Oconee Nuclear Station, Units 1, 2, and 3

Oconee External Flood, Response to Request for Additional Information (RAI)

Attachment 1: RAI Responses

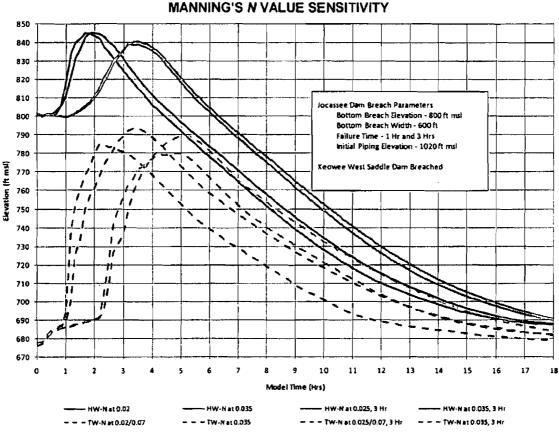
Justify the use of the different Manning *n* values for the following areas: Little River Basin below the channel, the Keowee River below the Jocassee tailrace, and in the Keowee tailrace extension to the road bridge. Specifically, describe how the *n* values selected represent a conservative value.

In addition, the Manning's n values were revised from 0.035 to 0.07 in the respective tailrace reaches below Jocassee Dam, Keowee Dam, ONS Intake Canal Dike, and Little River Dam to account for roughness associated with displaced dam breach material (suspended material and bed load). It is recognized that the Jocassee Dam (rock fill) material is different from the Keowee Reservoir dams (compacted soil). Both suspended material and bed load consume energy and cause an apparent increase in Manning's n. No attempt was made to evaluate Manning's n values for the respective dam locations and as such, a conservative value of 0.07 was assigned to the tailrace reach below each dam. A higher tailrace n value is assumed to result in a more conservative tailrace elevation profile below each breached structure and is believed to be applicable in this modeling effort. Based on the differences in the construction material of Jocassee verses the Keowee impoundment structures, it would be expected that the channel below the Jocassee breach would be rougher, with a corresponding higher Manning's n than that expected below the respective Keowee impoundment structures breached. However, the same n value is being used for the earthen dams (Lake Keowee impoundment structures) as for the Jocassee Dam (rockfill structure), thus a higher degree of conservatism is expected in determining the Keowee tailrace water surface elevations and the associated potential flooding of the Oconee site.

The affected reach lengths below each dam were limited to the base width dimension of the respective dams, followed by a second base width dimension (the width of the dam from the upstream toe to the downstream toe) to allow transition from 0.07 to 0.02. For example, the base width of Jocassee Dam is approximately 1300 feet at elevation 800 feet msl. Therefore, the Jocassee Dam tailrace would have a Manning's n value of 0.07 for a distance of 1300 feet below the downstream toe of the dam and an additional 1300 feet to transition from 0.07 to 0.02. The Manning's n transition was assumed to be linear.

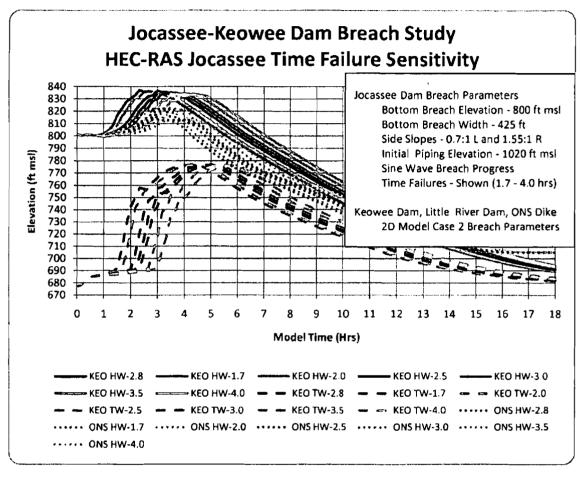
Provide the key for your runs associated with the sensitivity analysis for the Hydrologic Engineering Center – River Analysis System (HEC-RAS) model.

The HEC-RAS runs 1 through 98 shall be considered the 'sensitivity analysis' information for Cases 1, 2, and 3 (HEC-RAS runs 101, 100, and 99 respectively).

The target being monitored with this sensitivity analysis is the final water heights at and around the Oconee site. In order to do this evaluation, some parameters of the model will need individual sensitivity evaluations to determine their role in the overall outcome, or results. In other words, does or does not the individual parameter play a key role in determining the water height at Oconee. This can be done by varying the parameter and holding all other parameters constant.
